THE MARYLAND ZOO IN BALTIMORE

PERIMETER GATE REPORT

SEPTEMBER 2021

#20 PENGUIN EDUCATION GATE

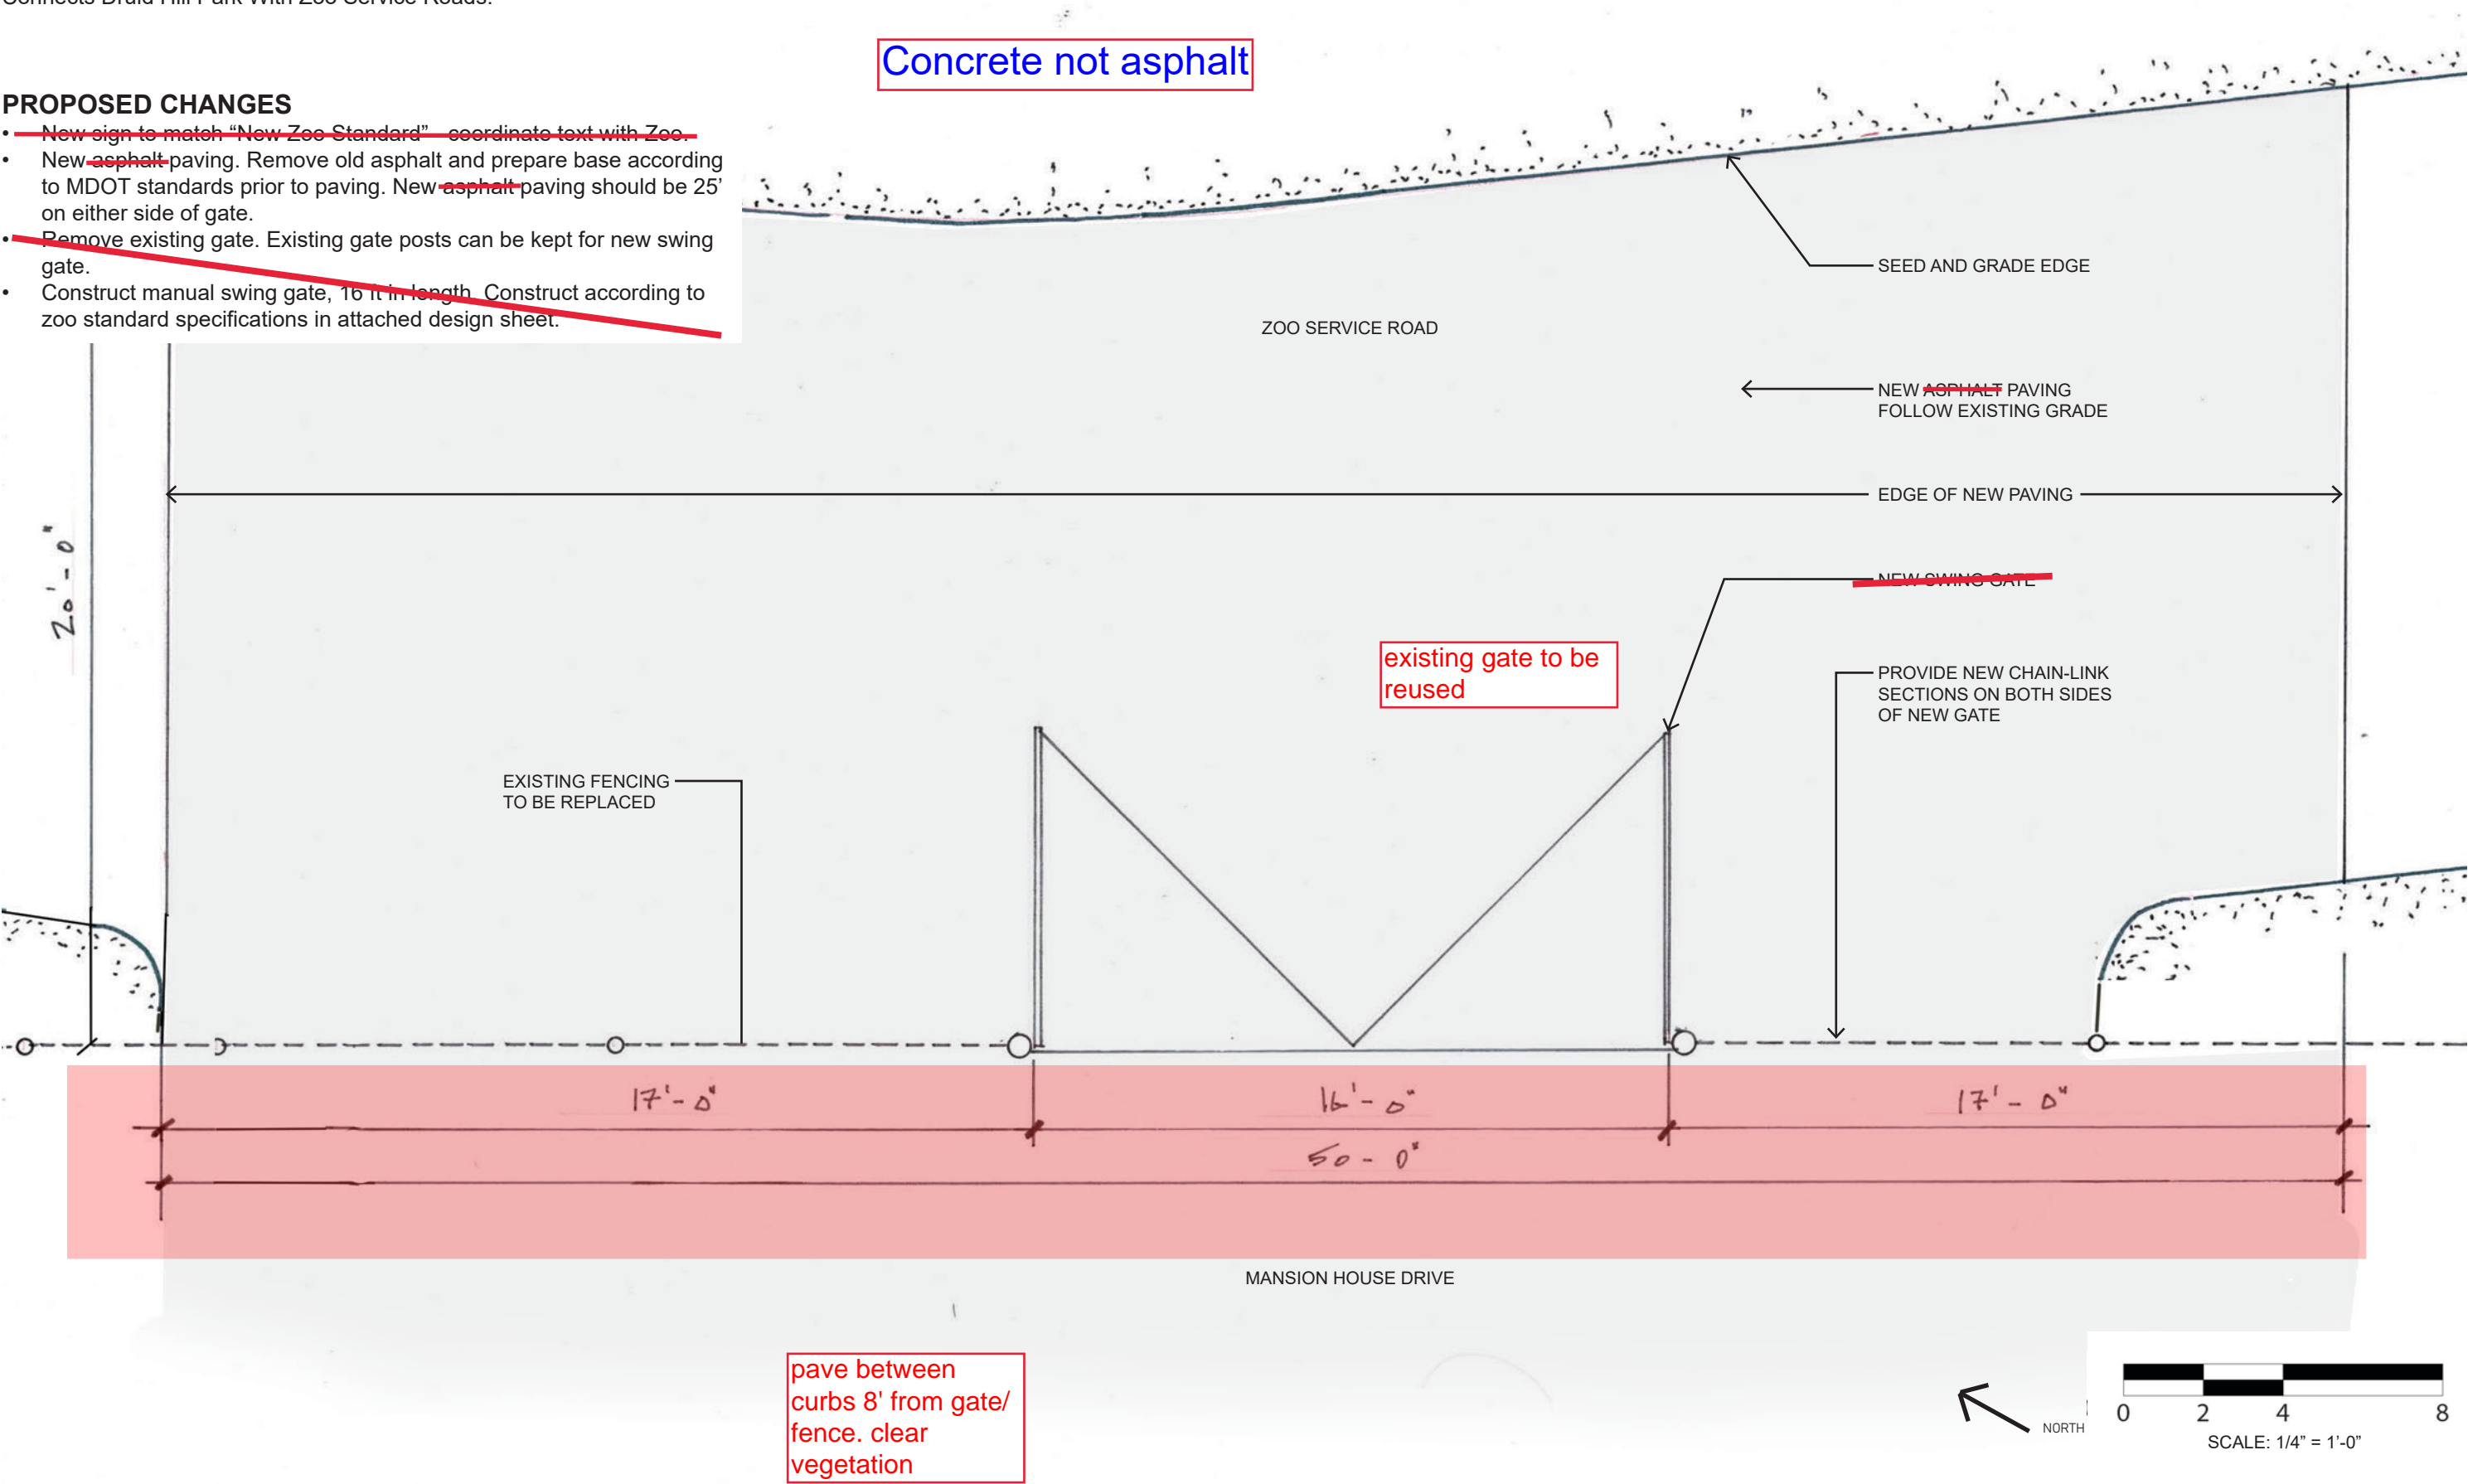
- ~~New sign to match "New Zoo Standard" coordinate text with Zoo.~~
- ~~New asphalt paving. Remove old asphalt and prepare base according to MDOT standards prior to paving. New asphalt paving should be 25' on either side of gate.~~
- ~~Remove existing gate. Existing gate posts can be kept for new swing gate.~~
- ~~Construct manual swing gate, 16 ft in length. Construct according to zoo standard specifications in attached design sheet.~~

#21 ELEPHANT GATE

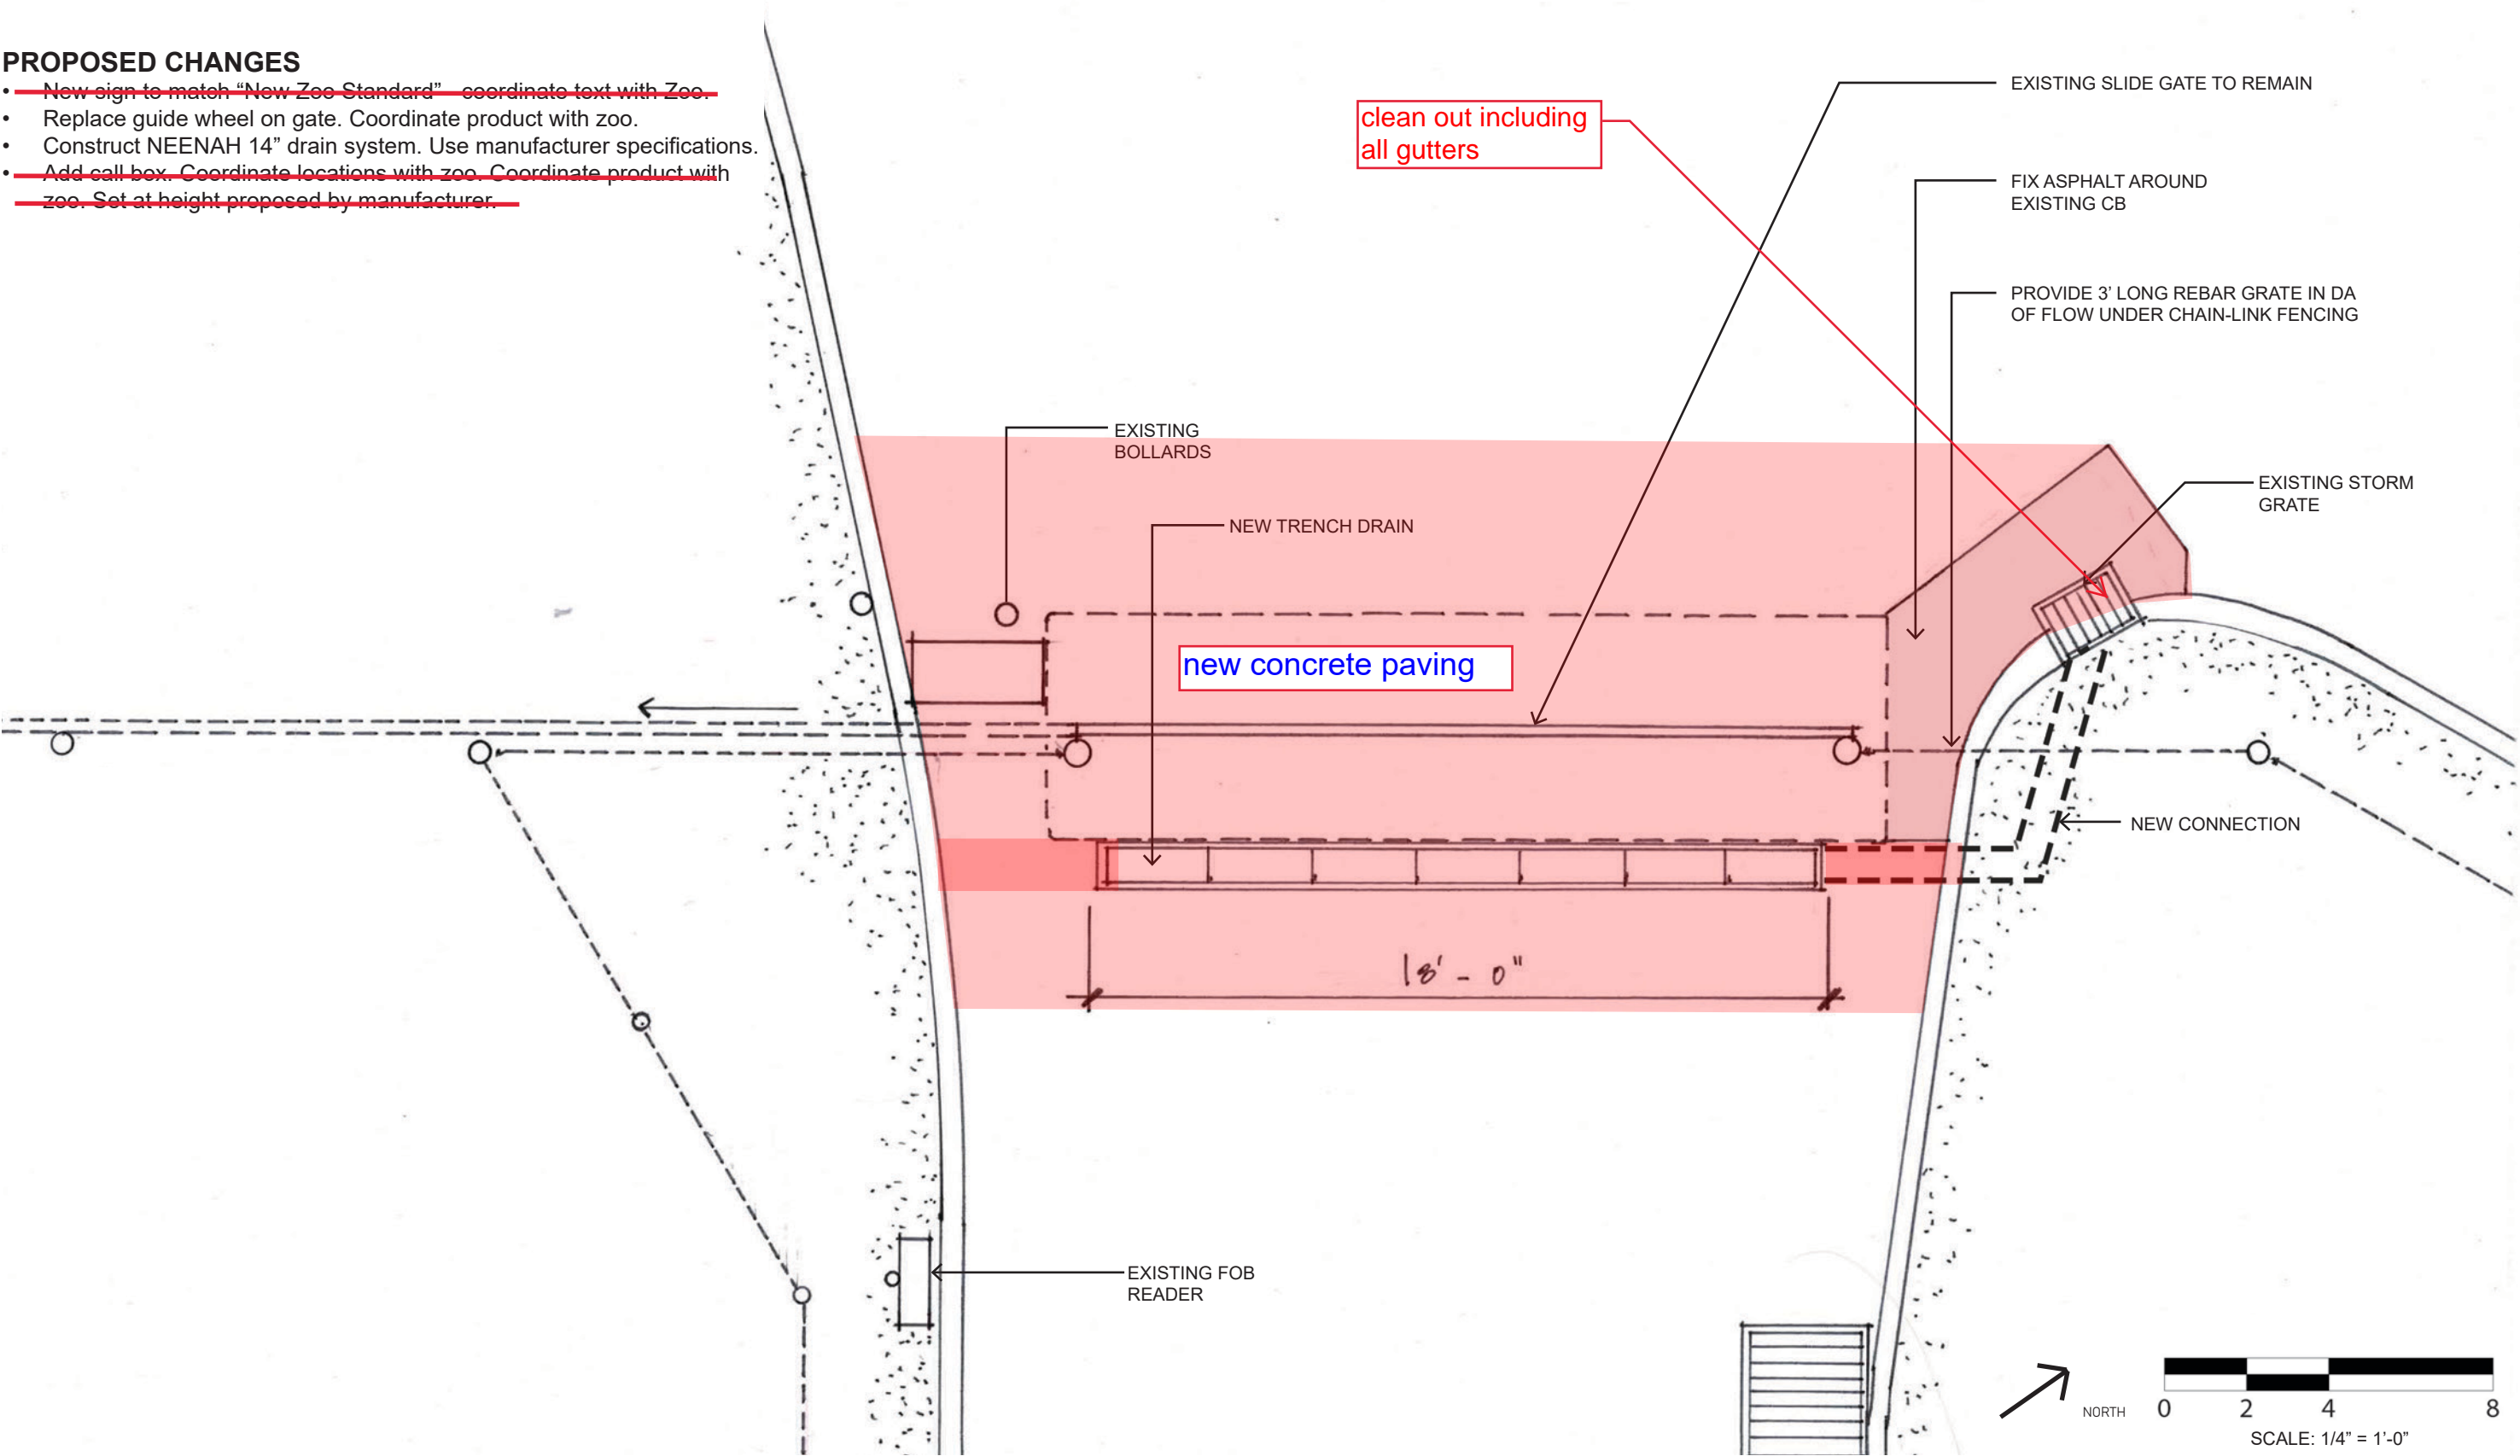
- ~~New sign to match "New Zoo Standard" coordinate text with Zoo.~~
- Replace guide wheel on gate. Coordinate product with zoo.
- Construct NEENAH 14" drain system. Use manufacturer specifications.
- ~~Add call box. Coordinate locations with zoo. Coordinate product with zoo. Set at height proposed by manufacturer.~~

#23 MAINTENANCE GATE

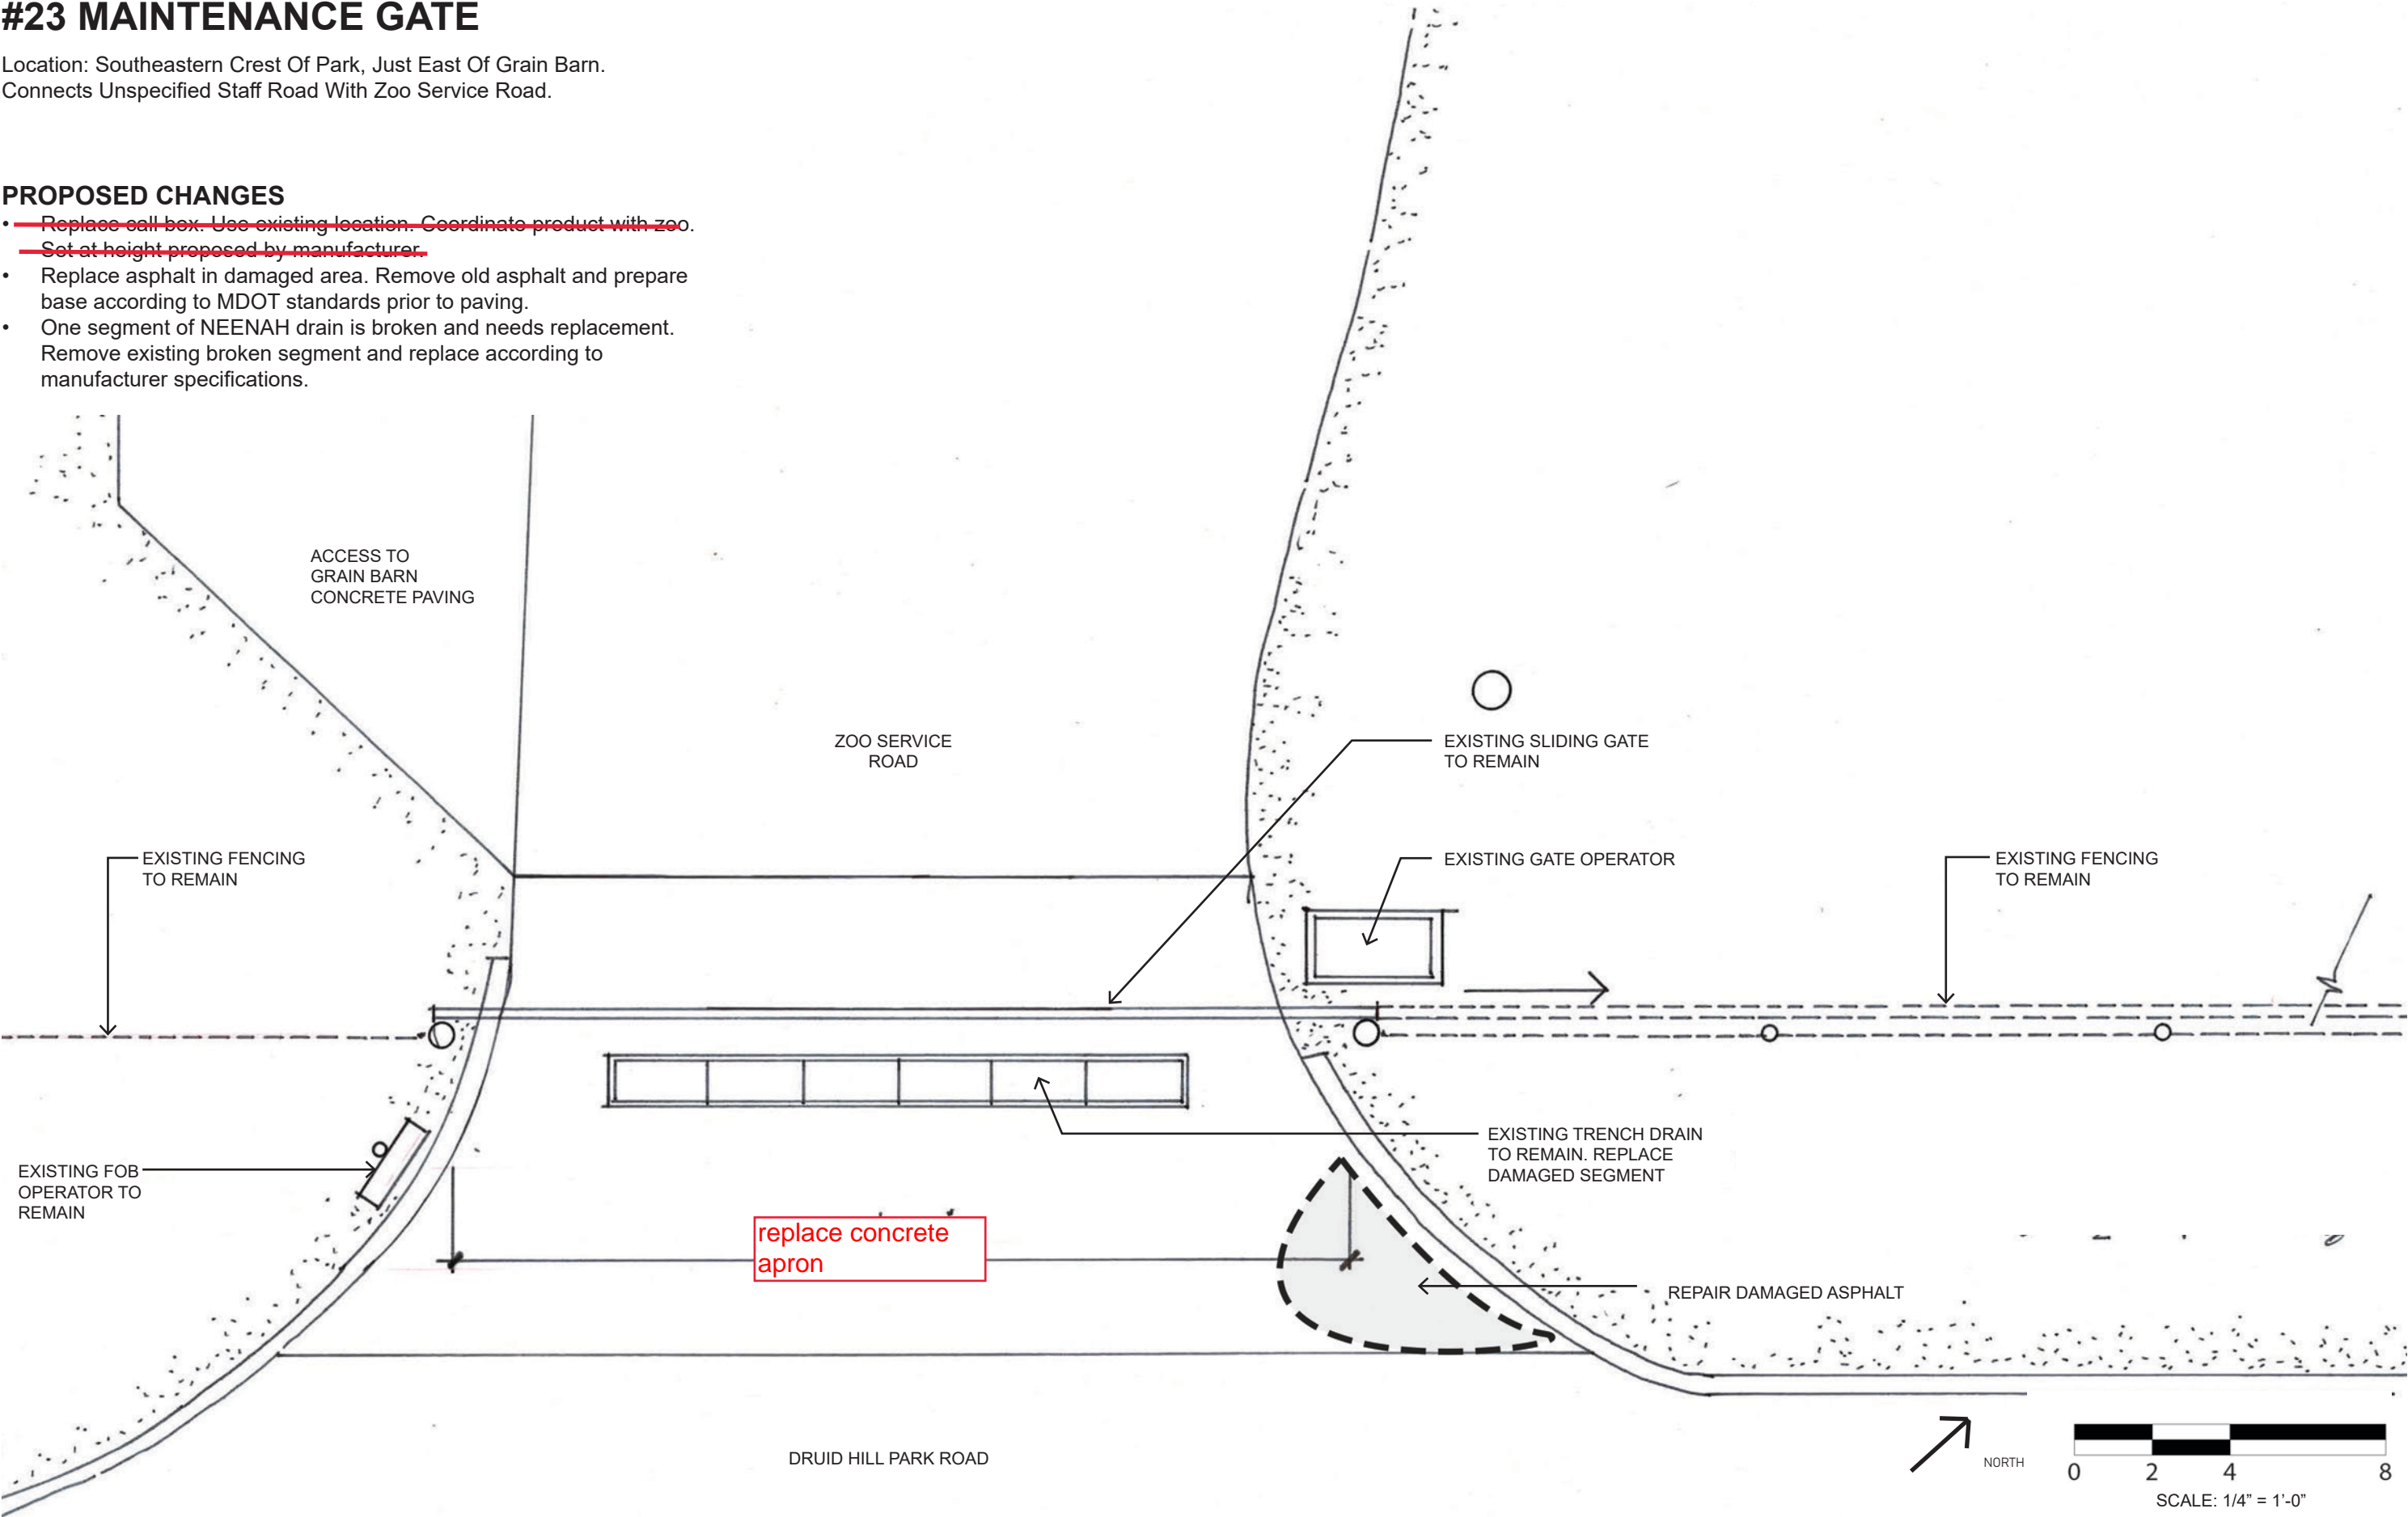
- ~~Replace call box. Use existing location. Coordinate product with zoo.~~
~~Set at height proposed by manufacturer.~~
- Replace asphalt in damaged area. Remove old asphalt and prepare base according to MDOT standards prior to paving.
- One segment of NEENAH drain is broken and needs replacement. Remove existing broken segment and replace according to manufacturer specifications.
